UNITED STATES PATENT AND TRADEMARK OFFICE

10/528,593

Office Action Summary

DETAILED ACTION

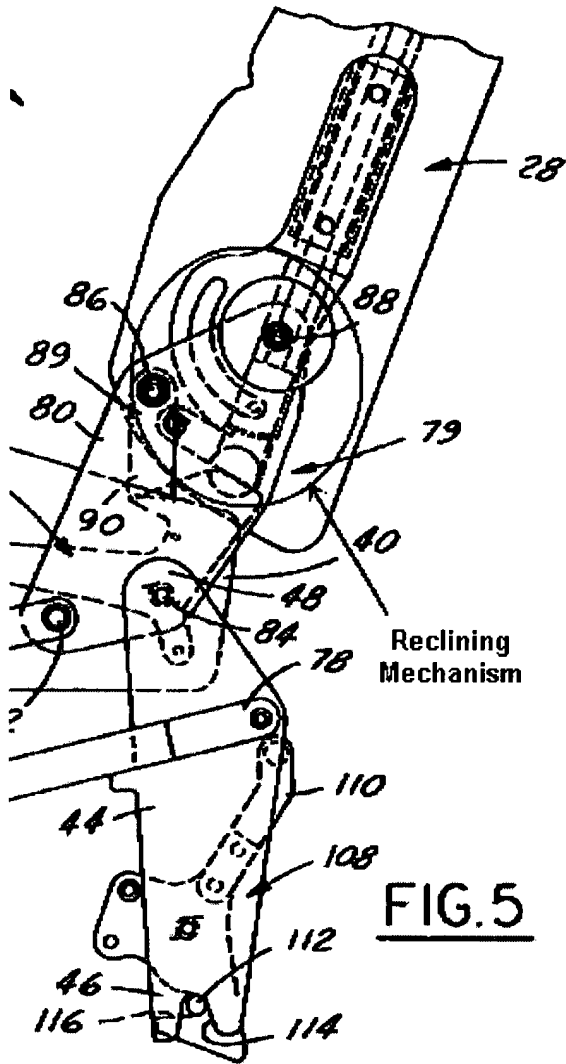
Re claim 1, Schaefer discloses a seat assembly comprising a seat cushion (36), a seat back (28), at least one recliner mechanism (see the illustration below) linking the seat back to the seat cushion, a riser assembly including front (50) and rear legs (44), the riser assembly coupled to the seat cushion and a floor of a vehicle for allowing selective movement of the seat cushion, and at least one link mechanism (79) operatively connected to the seat back and the seat cushion, the at least one link mechanism moving the seat cushion in response to pivotal movement of the seat back (as shown in figure 7).

Re claim 20, Schaefer et al. discloses a seat assembly comprising a seat cushion (42), a seat back (28), at least one recliner mechanism (see the illustration above) linking the seat back to the seat cushion for selective adjustment of the seat back relative to the seat cushion between seating, easy entry and stowed positions, a riser assembly including front (50) and rear legs (44), the riser assembly coupled to the seat cushion and a floor of a vehicle for allowing selective movement of the seat cushion, and at least one link mechanism (79) operatively connected to the seat back and the seat cushion, the at least one link mechanism freely moving about pivot pins when the seat back is moved from the seating to the easy entry position, and wherein the at least one link mechanism locks urging forward pivotal movement of the front and rear legs when the seat back is urged forward past the easy entry position (as shown in figure 7).
